**0013 Technical Service Information****Subject: Cylinder head gaskets****Relates to: 61-34162-00 / -10****Make: Opel****Model(s): Agila, Astra, Corsa****Engine code: X 12 XE, Z 12 XE****Repair thickness CHG 1.2 Opel  
Ecotec X 12 XE / Z 12 XE**

Figure\_Cylinder head gasket, Reinz no. 61-34162

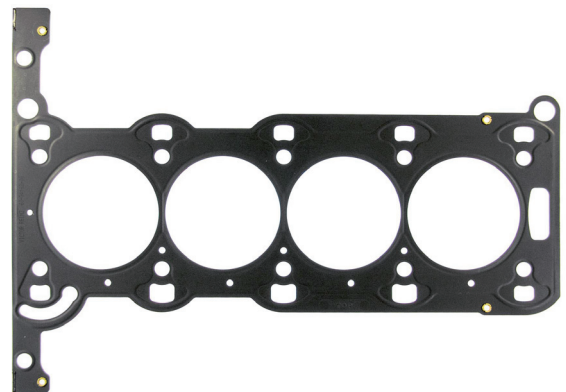
With the new exclusive repair thickness for the Cylinder Head Gasket 61-34162-00 = Opel 56 07 448, Dana offers the perfect solution for reliable sealing of reworked cylinder heads and cylinder blocks.

The repair thickness is 0.25 mm thicker than the original. After necessary surface machining, this thickness thus offers best sealing results up to this measurement.

The order number for the repair thickness is **61-34162-10**.

Caution: After the cylinder head and cylinder block have been machined, the surface roughnesses must be in a tolerance band between 7 µm and 20 µm. The waviness value should not exceed 20 µm.
